TECHNICAL BULLETIN

SU-06-05

**MODEL AFFECTED:** UH-1H

**SUBJECT:** ALTERNATE SPARE PART; SYNCHRONIZED ELEVATOR P/N 205-030-856-169 AND 205-030-856-171

FIGURE 1

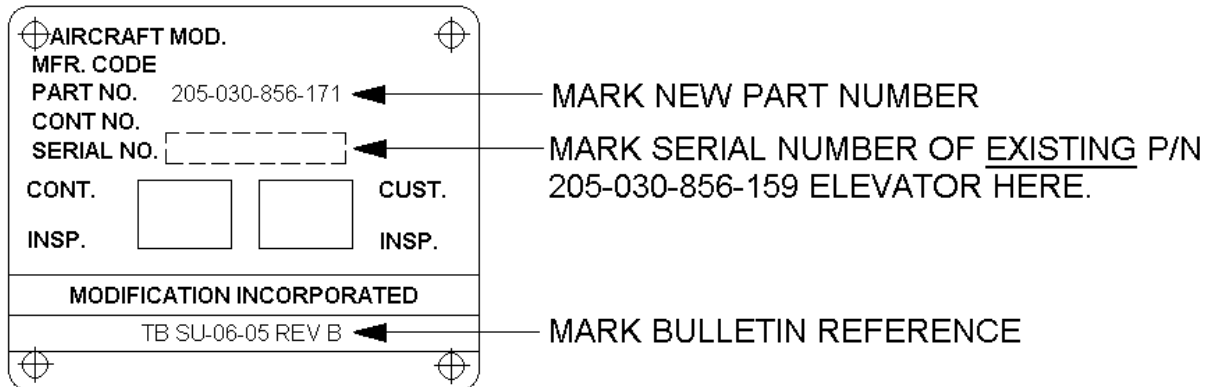
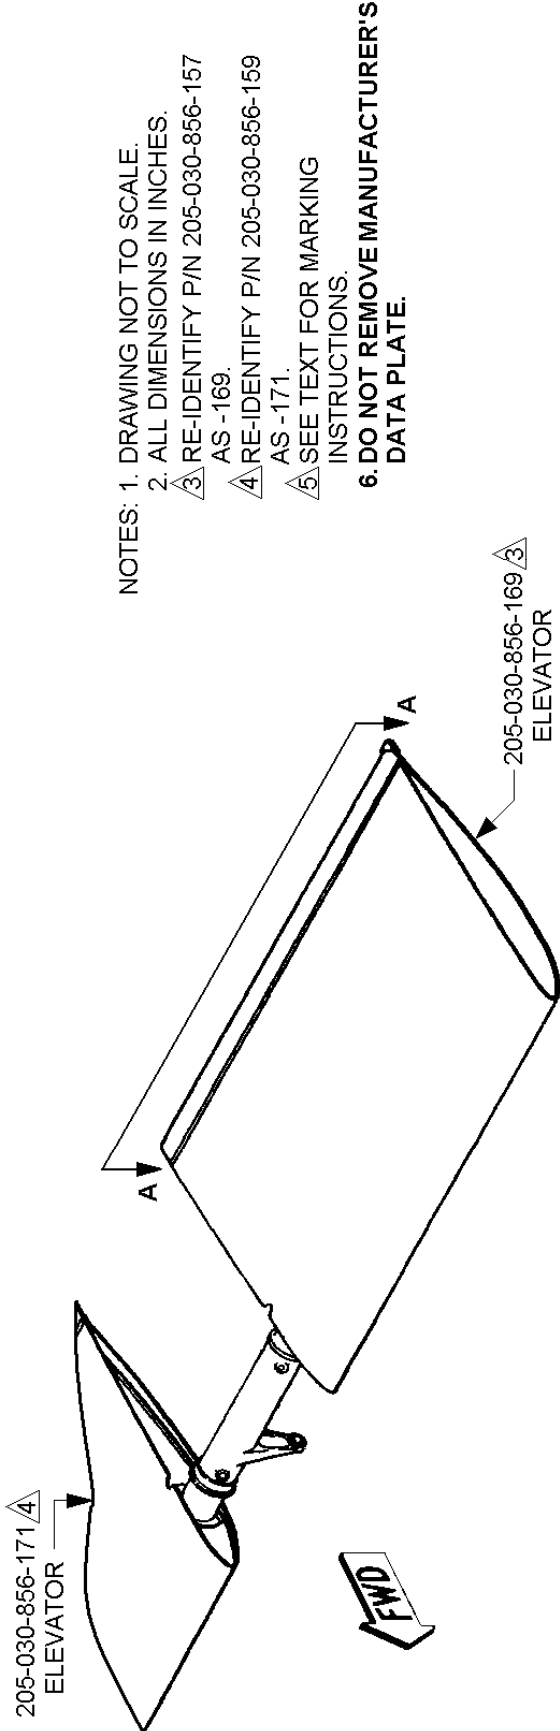
- b. Populate a P/N MS27253-1 modification plate as shown in Figure 1. Existing P/N 205-030-856-157/-159 elevator serial numbers shall not be changed or altered.

NOTE: MARK MS27253-1 MODIFICATION PLATE USING IMPRESSION STAMP, DOT PEEN, OR VIBROSCRIBE ONLY.

**FIGURE 2**

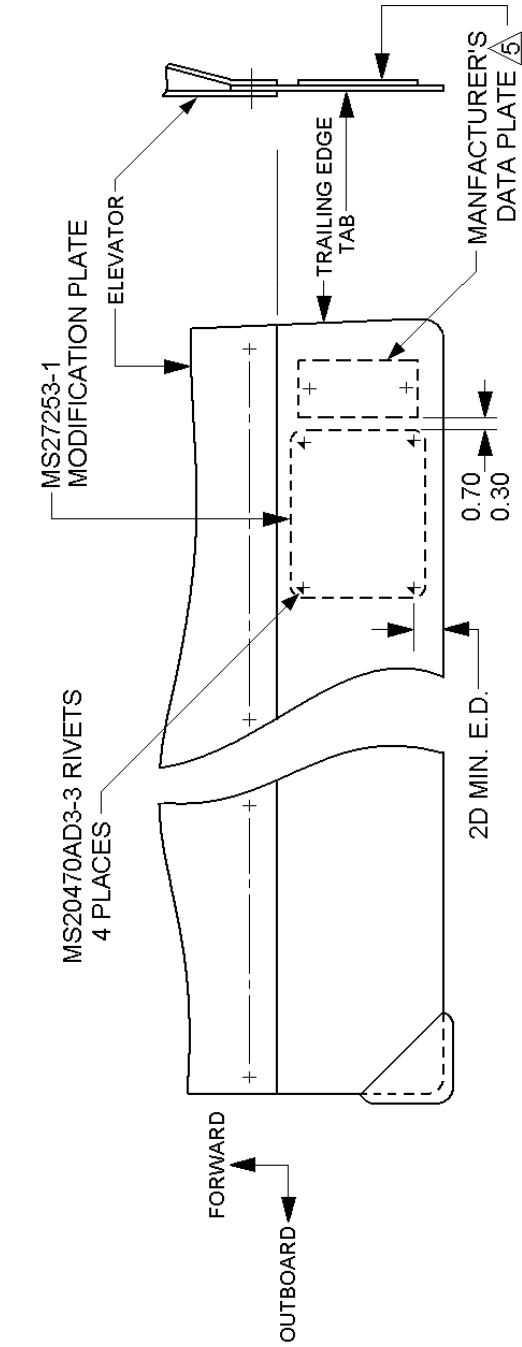
- c. Install the modification plate on the appropriate elevator assembly as shown in Figure 2. **Do not remove the existing manufacturer's data plate.**

- 1) Locate the modification plate and back drill four fastener holes in the elevator tab. Use care to not bend the tab.
  - 2) Remove the modification plate and deburr holes in the elevator tab.

- 3) Install each modification plate with four (4) MS20470AD3-3 rivets. Install fasteners with wet primer. Remove excess primer and allow primer to cure.

- NOTES: 1. DRAWING NOT TO SCALE.  
 2. ALL DIMENSIONS IN INCHES.  
 3 RE-IDENTIFY P/N 205-030-856-157 AS -169.  
 4 RE-IDENTIFY P/N 205-030-856-159 AS -171.  
 5 SEE TEXT FOR MARKING INSTRUCTIONS.  
 6. DO NOT REMOVE MANUFACTURER'S DATA PLATE.
